SERVICE BULLETIN

EOS engine

date of release	.Nov. 2018	issue 1, #1118_1_m
for engine type / applicability	all engines EOS 150 (ICI)	
status	mandatory	optional

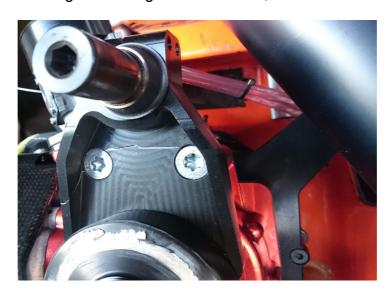
So far two cases have been reported where the mount bracket of the drive wheel has failed. One time due to the use of a non from us recommended propeller type (3-blade propeller) where due to date it is unknown if the used propeller had a unbalanced condition and therefore extensive vibrations occured or whatever else has happened. Another time where it was reported to us that the pilot had a crash landing and possible prop strike. The following picture shoing the damage of the bracket;

In case of a crash and/or prop strike, the bracket could fail istantly and brake appart into 2 pieces or brake partly as shown. In case of continuous and extensive vibrations due to propeller imbalance the damge can occure in steps where a crack starts to appear between the upper M8 bolts and in consequence continuing to brake the left and right reinforcement walls.

Before any new engine operation whether on ground or for flight it is imperative to check

this subject mount bracket of the drive wheel if it is showing any similar damage, crack or damage whatsoever.

In case a same or similar damage will be detected we advice the engine owner to contact with EOS engine for further procedure and change of the bracket to new.
